# North of 7 Master Plan

## Environmental Assessment Addendum

February 10, 2020

**Prepared for:** Town of Perth

Figure 2-1. Preferred Alternative from the DEA Report

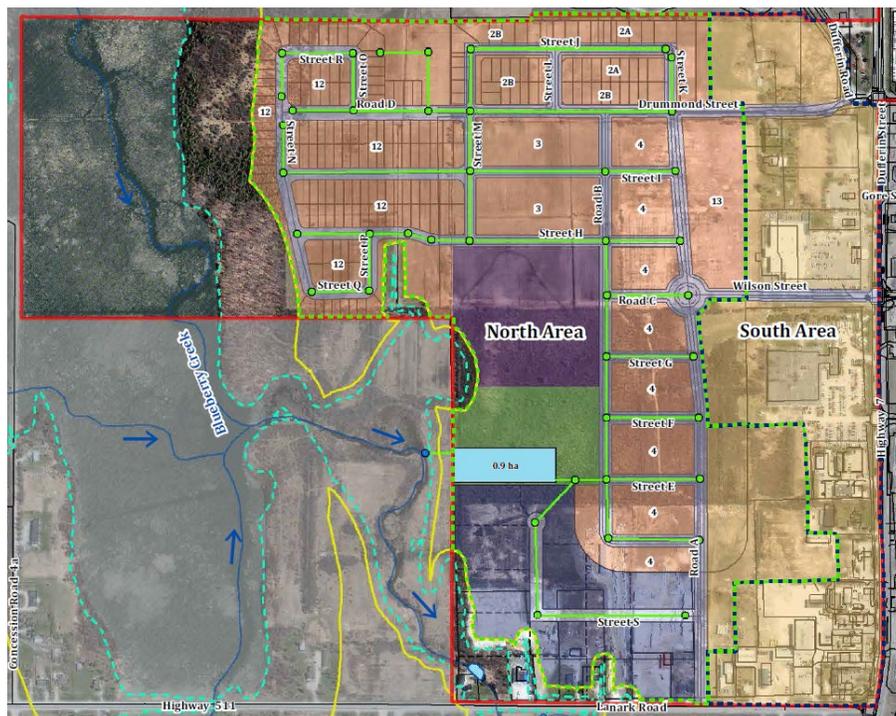
The Infrastructure Master Plan for Area North of Highway 7 (Dillon, 2013, referred to herein as DEA) found the preferred alternative for stormwater management in the North of Seven development would be to collect water via conventional catchbasins and storm sewers, and then pump the collected stormwater into a conventional stormwater management pond. Figure 2-1 shows the preferred alternative.

1:10,000	Figure - 1 Revised Environmental Constraints
	Drawn By: PJ
Project: 2161774A	Checked by: DN
	Date: July 2016

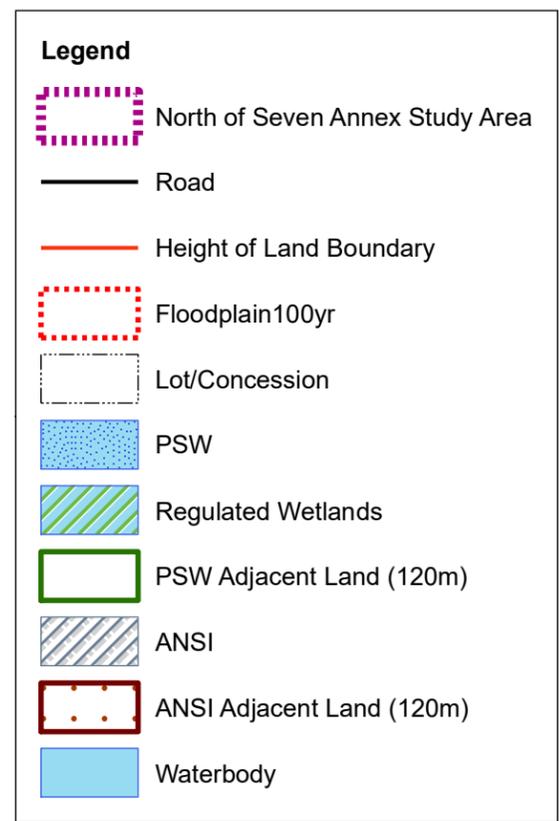
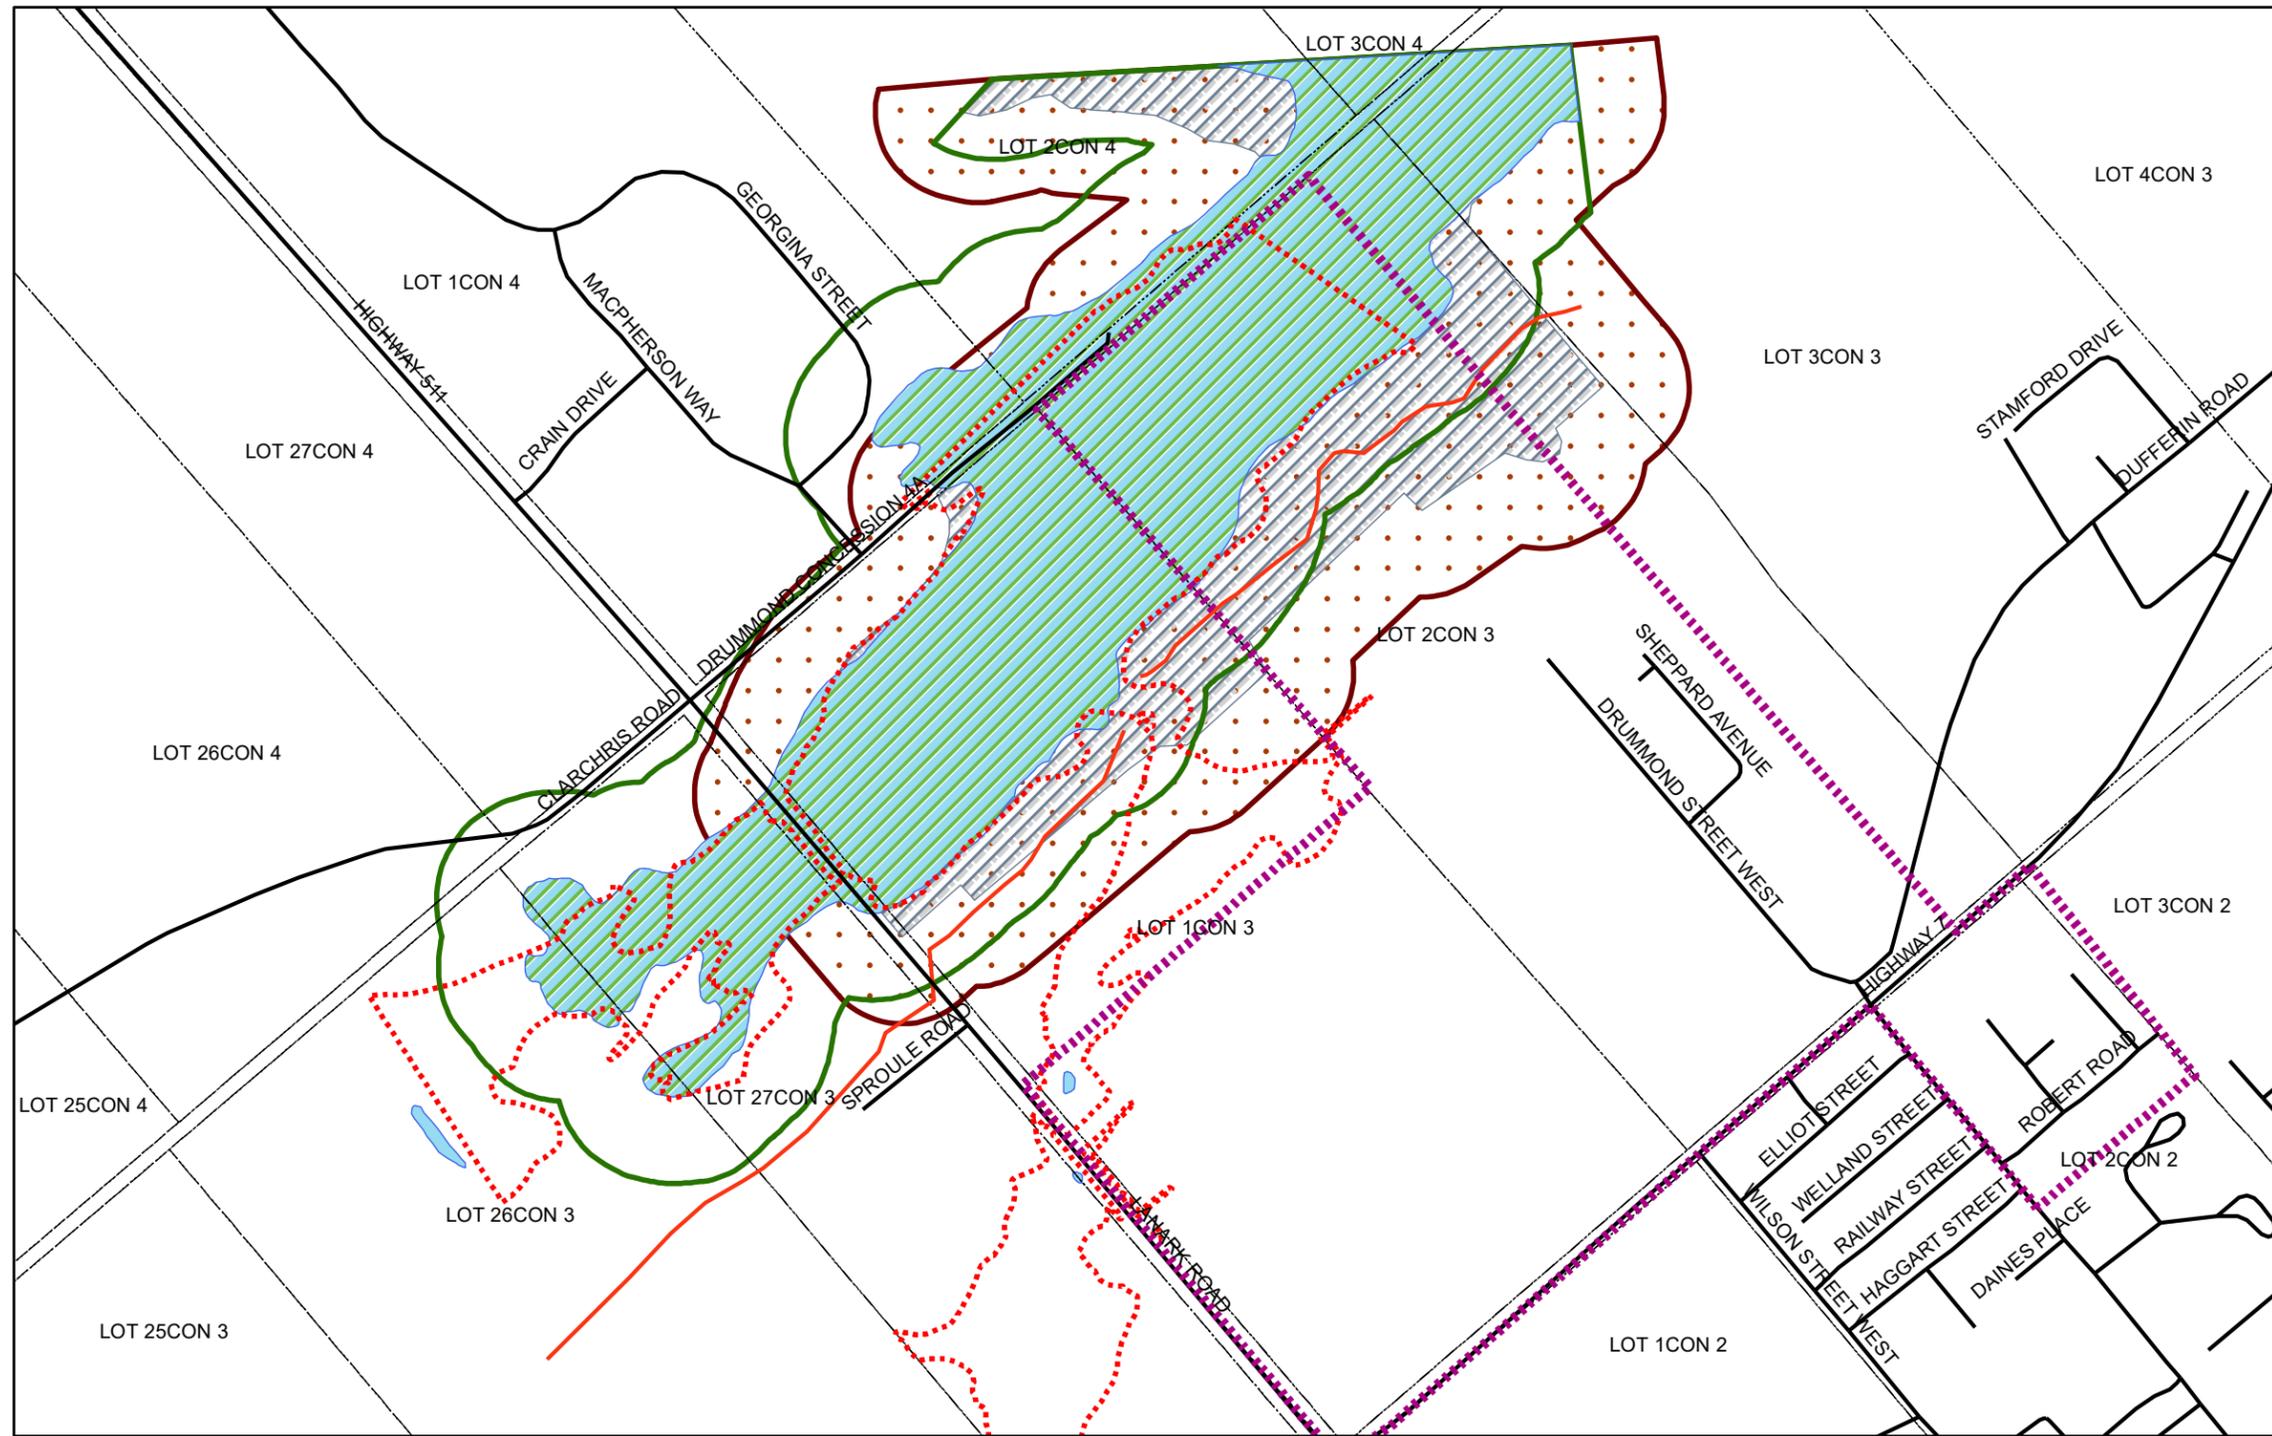
Omission/Weakness	Action Required	Action By
The RVCA regulation limit is shown as 15m from the 1:100 year flood line and 120m from the PSW. The preferred solution concept plan shows the regulated lands as a Moderate Constraint. This is not the intent of the regulation limit.	HIA required to revise development limit. Follow RVCA policy to place fill in flood plain.	Developer
Catchment area of Wetland should be shown distinct from Creek, to allow for consideration of different criteria for releases. Releases to the PSW would have to demonstrate no impact on the hydrologic function of the wetland. Releases to the creek would have to demonstrate post-to-pre peak flow, and no impact on channel stability.	Revise catchment boundaries	Developer
Candidate ANSI not discussed or considered as an ecological constraint.	EIS required within ANSI limits	Developer
Planning restrictions due to the Intake Protection Zone (IPZ) is not discussed. This may not have been available at the time of developing the Master Plan, but those restrictions are present today. The County of Lanark Amendment No. 3 was approved by MMAH October 16, 2015 which implemented source water protection policies.	Discuss implications of IPZ, and determine if IPZ acts as constraint.	Town

Omission/Weakness	Action Required	Action By
Stormwater Management (Section 6.4) has not considered specific variants on conveyance and quantity controls (LIDs). Specifically, a grassed swale with ample underdrainage can be used in the place of a conventional pipe-and-pond system in providing conveyance, treatment, and storage.	Conceptual master drainage plan will have to be developed.	Town and Developer

If a revised boundary will change the servicing requirements for the development, then the terms of reference for the associated studies would be required to be defined as part of the Class EA, in order to determine the servicing requirements. The attached Figure 1 Revised Environmental Constraints shows the following environmental constraints to development, in comparison to Figure 6 in the Master Plan:

- a) The Blueberry Creek 1:100 Flood Elevation based on the RVCA Flood Risk Mapping July 2, 2010 on both figures.
- b) The limits of the Blueberry Marsh PSW based on the County and Town Official Plan on both figures.
- c) The 120m area of influence on adjacent lands from the PSW based on the County and Town Official Plan policies Section 5.5.1.6 and Section 8.6.4b.3 respectively is on both figures.
- d) The limits of the Candidate Perth Blueberry Marsh ANSI based on the County Official Plan is shown on Figure 1.
- e) The 120m area of influence on adjacent lands from the ANSI based on the County policy Section 5.5.3.2 is shown on Figure 1.
- f) The height of land is shown on Figure 1 which defines the surface water flow in the vicinity of the wetland and creek.

For the purposes of the Class EA, which is intended to evaluate the potential infrastructure requirements, the developable land can be assumed to be the largest reasonably possible developable area. When the EA is reopened, the consultant will determine if the PSW or ANSI setbacks are appropriate for this stage in the planning process. At the time of an application for Subdivision for the area, the proponent will be required to demonstrate through both EIS and HIA what the appropriate setback to development would be within the Subdivision.
